City of Phoenix PLANNING AND DEVELOPMENT DEPARTMENT

Staff Report Z-19-21-8 July 1, 2022

Request To: [WU Code T4:3 GW](#) (Walkable Urban Code, Transect 4:3 District, Transit Gateway Character Area) (11.46 acres)

Conceptual Site Plan Date Stamped March 21, 2022

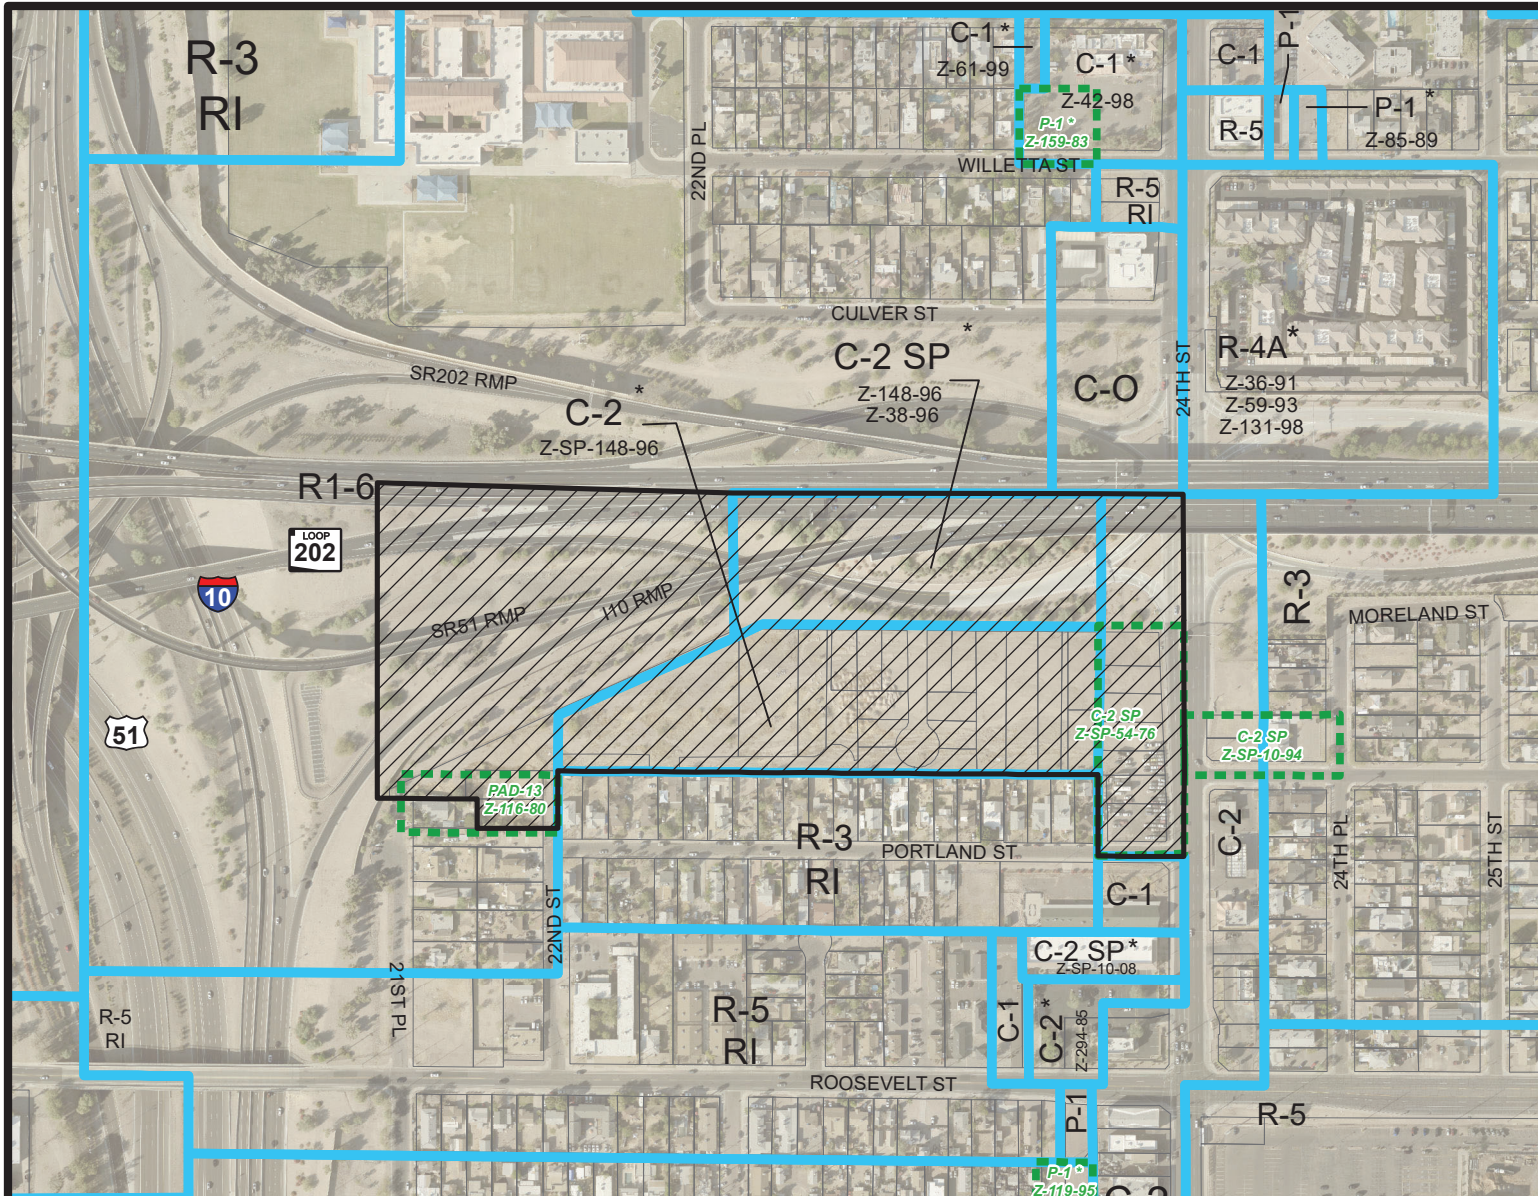
6. The proposed WU Code T4:3 District is described as a low-intensity urban residential fabric characterized by single-family homes, duplexes, single-family attached, and small multifamily developments. As shown on the conceptual site plan attached as an exhibit, the proposed development consists of ten two- and three-story residential buildings with a maximum height of 33 feet. The proposal includes a building with frontage on 24th Street and a leasing office at the corner

of 24th Street and Portland Street. The 24th Street frontage would be required to have a minimum of 60 percent building frontage, and the frontage must meet the frontage type requirements outlined in Chapter 13 of the Zoning Ordinance. Additionally, detached sidewalks will be required along the street frontage with a 5-foot-wide landscape area between the sidewalk and back of curb. The site plan depicts vehicular access through a driveway on 24th Street, leading to drive aisles and parking lots throughout the site and an exit-only gate to 22nd Street near the western edge of the property.

7. Because the site is over five acres, it will be considered a large-scale development, according to Section 1304.G of the Zoning Ordinance, which may require revisions to the conceptual site plan attached as an exhibit. Five percent of the lot area shall be provided as a public open space, and the plan shall include improvements to thoroughfares and pedestrian access. These revisions will be addressed during the development review process.
8. Section 1304.C. of the Zoning Ordinance requires that all sides of a building exhibit design continuity and multiple exterior accent materials. The provided conceptual elevations attached as an exhibit show multiple exterior accent colors, materials, and design continuity throughout all sides of the building.

The City of Phoenix is committed to its waste diversion efforts and has set a goal to become a zero-waste city, as part of the city's overall 2050 Environmental Sustainability Goals. One of the ways Phoenix can achieve this is to improve and expand its recycling and other waste diversion programs. Section 716 of the Phoenix Zoning Ordinance establishes standards to encourage the provision of recycling containers for multifamily, commercial and mixed-use developments meeting certain criteria. The proposed conceptual site plan and application materials did not reference recycling containers.
